STERLING RANCH ROAD CROSSING
COUNTY OF EL PASO, STATE OF COLORADO
GUARDRAIL PLAN
OCTOBER 2022

CDR-226

STERLING RANCH ROAD CROSSING
GUARDRAIL PLAN

GUARD RAIL PLAN

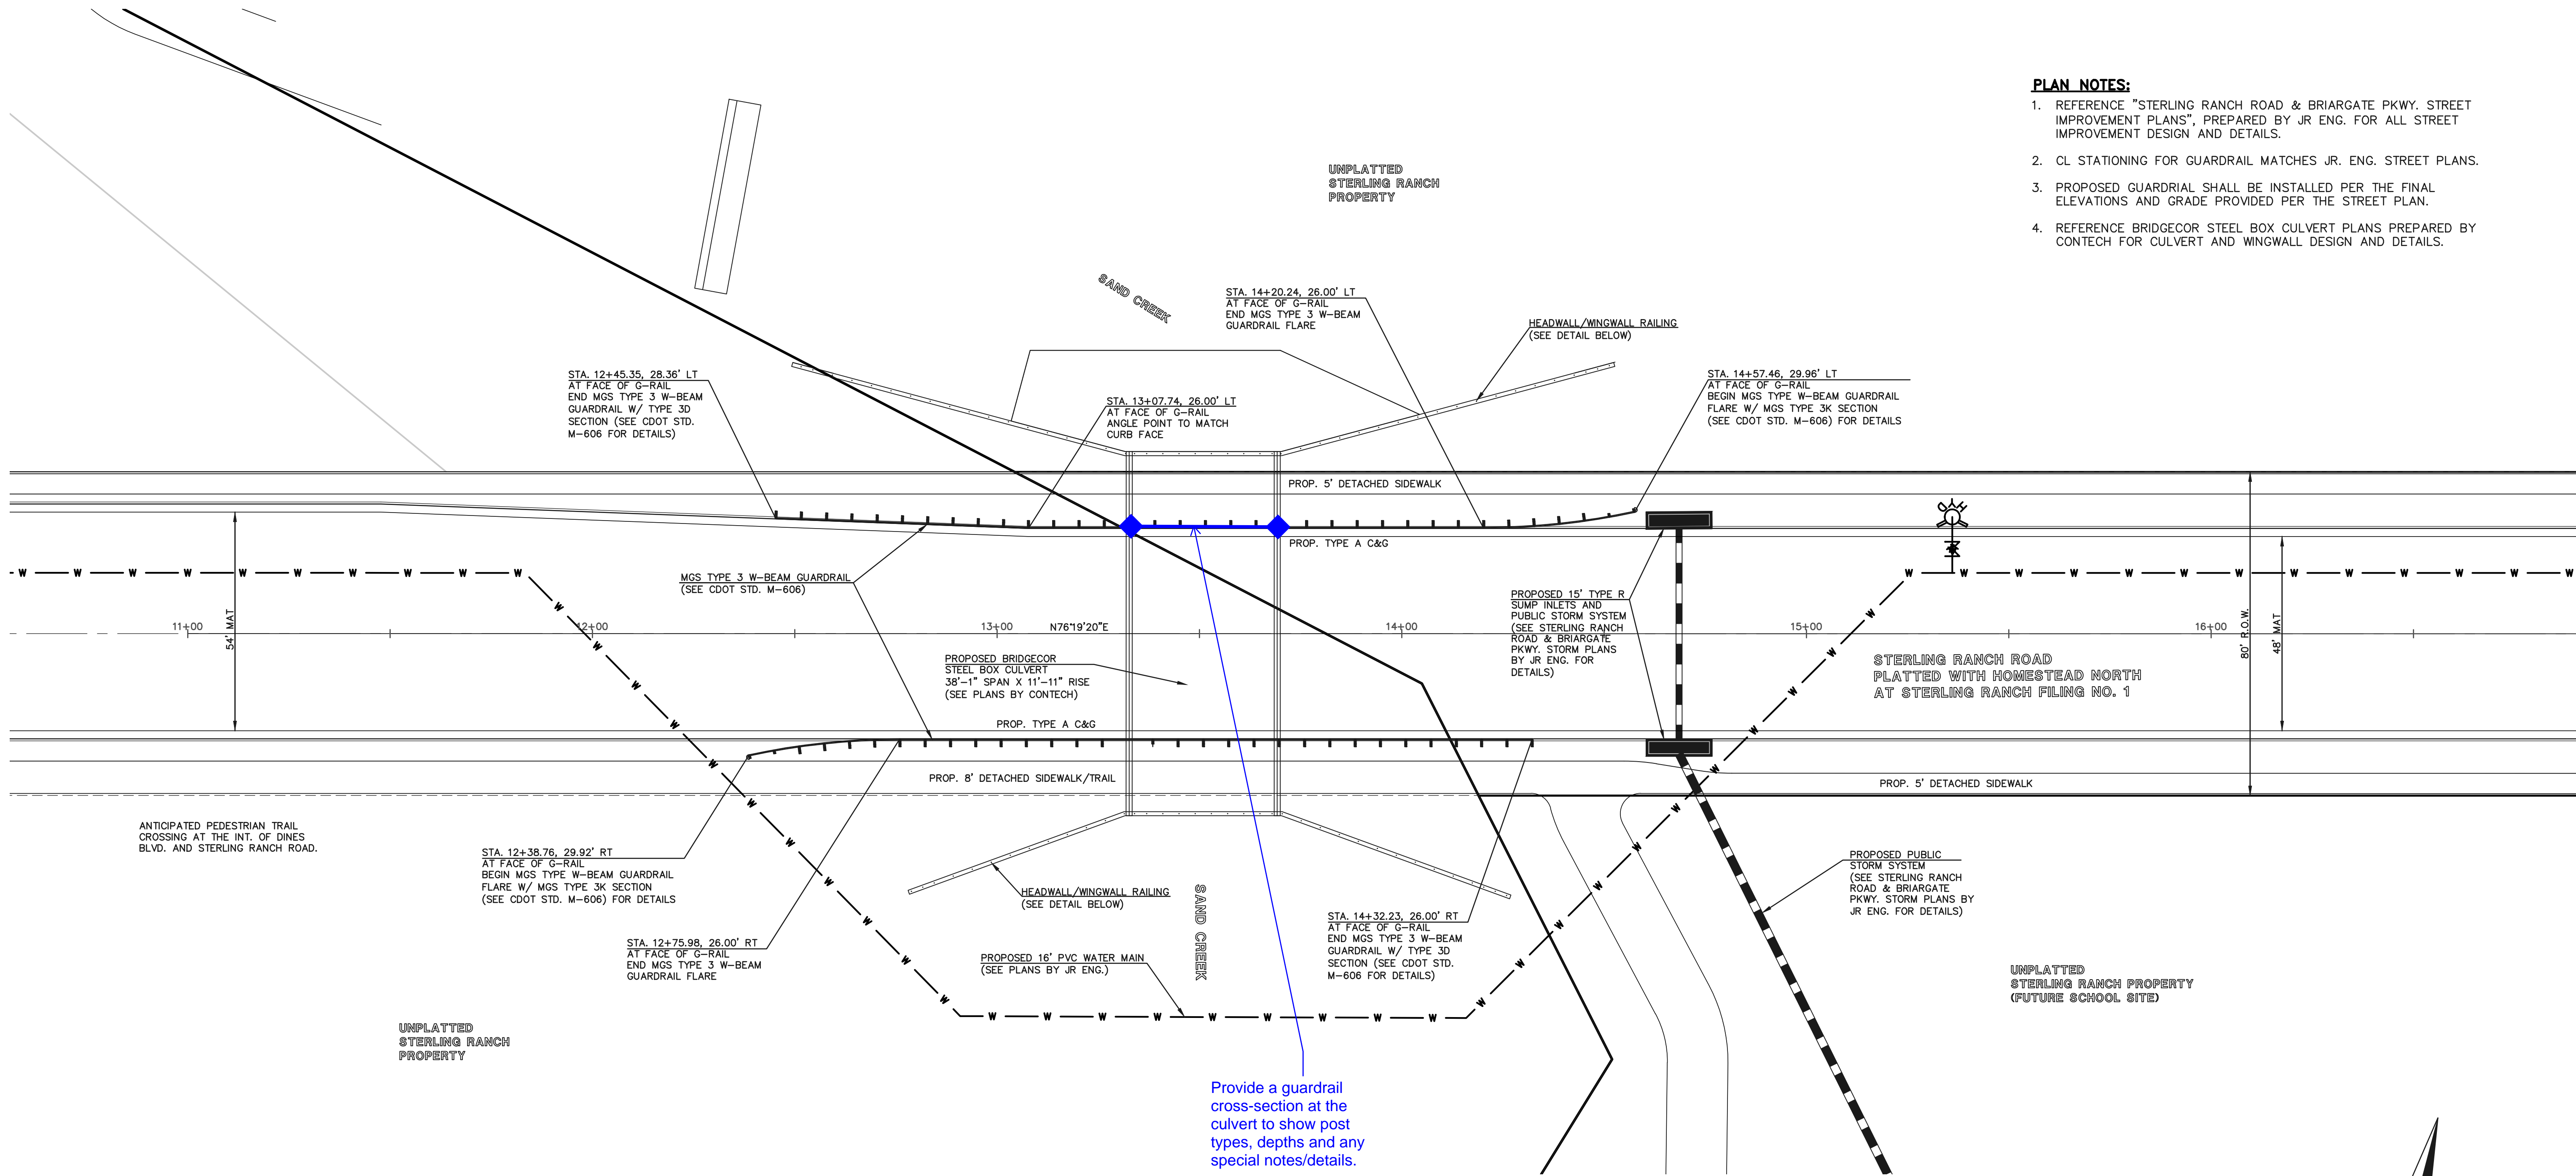
Provide a guardrail cross-section at the culvert to show post types, depths and any special notes/details.
